Applicants : Scott D. Brandenburg et al.  
Appln. No. : 10/624,063  
Page : 3

### **REMARKS**

Att. Docket No. DP-309190 (DEL01 P-440)  
Appl. No. 10/624,063  
Amendment Dated December 21, 2005  
Reply to Office Action Mailed September 21, 2005  
Annotated Sheet 1 of 2 Showing Changes

FIG. 2

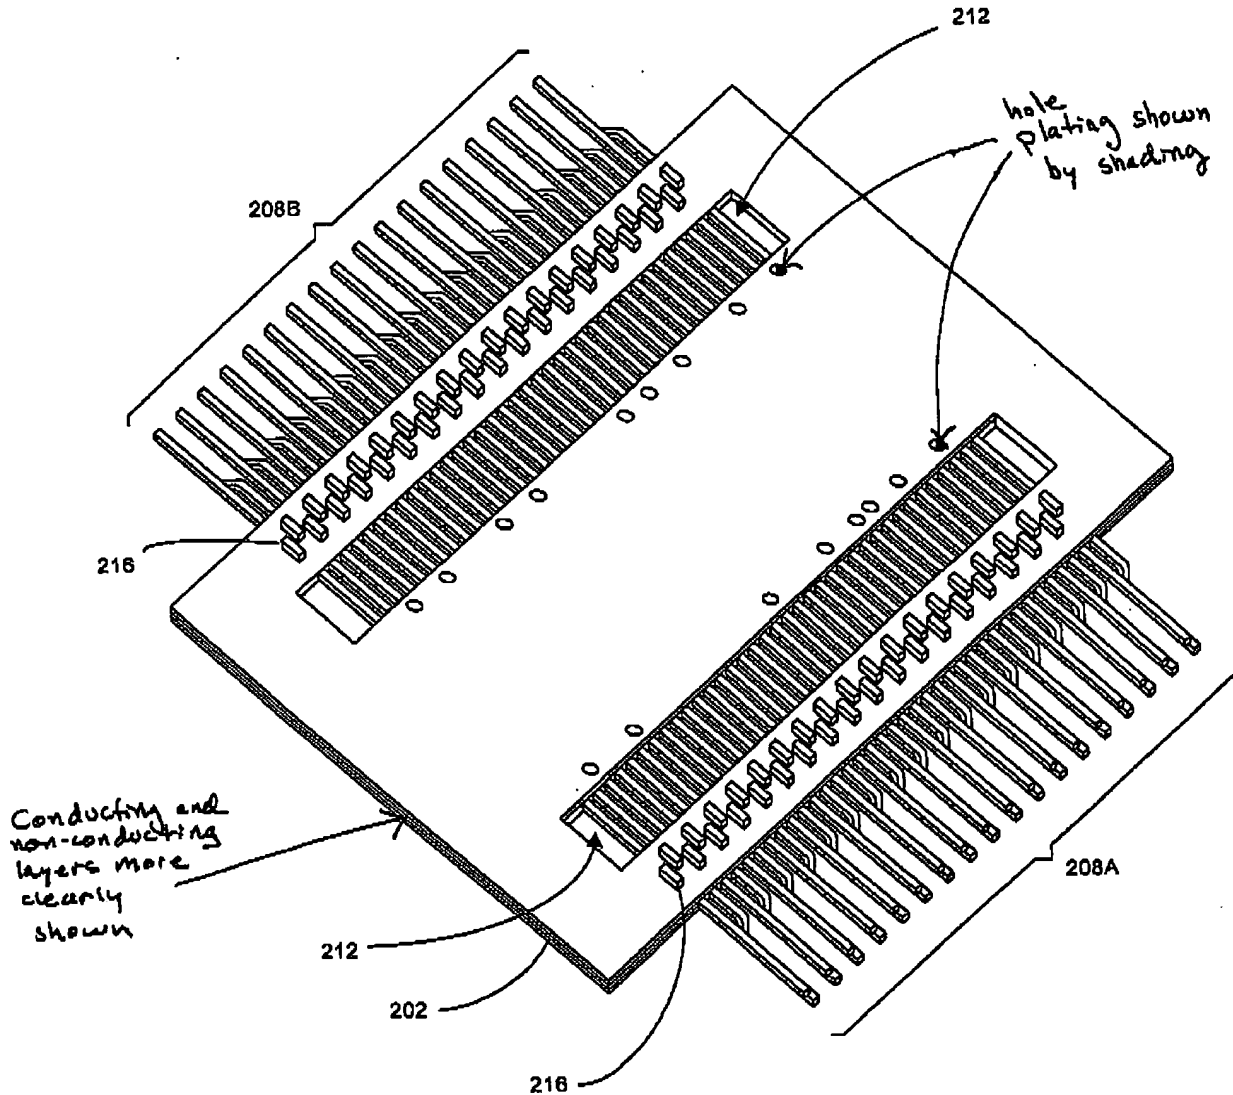
In the present non-final Office Action, the Examiner objected to the drawings under 37 C.F.R. § 1.83(a). Applicants have provided corrected drawing sheets clearly showing the PCB including a plurality of conductive layers, each separated by a non-conducting layer, at least one conductive trace of the PCB "plated through [sic] holes," and an automotive assembly. Because these elements were already disclosed in the claims and specification, the changes made to the drawings do not introduce new matter. Applicants respectfully submit that, with these changes, the drawing objection is now moot and the drawings are in condition for acceptance. Therefore, Applicants respectfully request that the objection to the drawings be withdrawn.

The Examiner also stated that "the drawings do not support for the claimed invention." As noted above, Applicants have corrected the drawings to satisfy the Examiner by showing an automotive assembly. Based on the foregoing discussion, Applicants respectfully submit that the rejection of claims 16-21 under 35 U.S.C. § 112, first paragraph, should be withdrawn for at least these reasons.

AUTOMOTIVE ASSEMBLY SHOWN

The attached sheets of drawings include changes to Figs. 2 and 2A. The replacement sheets, which include Figs. 2 and 2A, replace the original sheets including Figs. 2 and 2A.
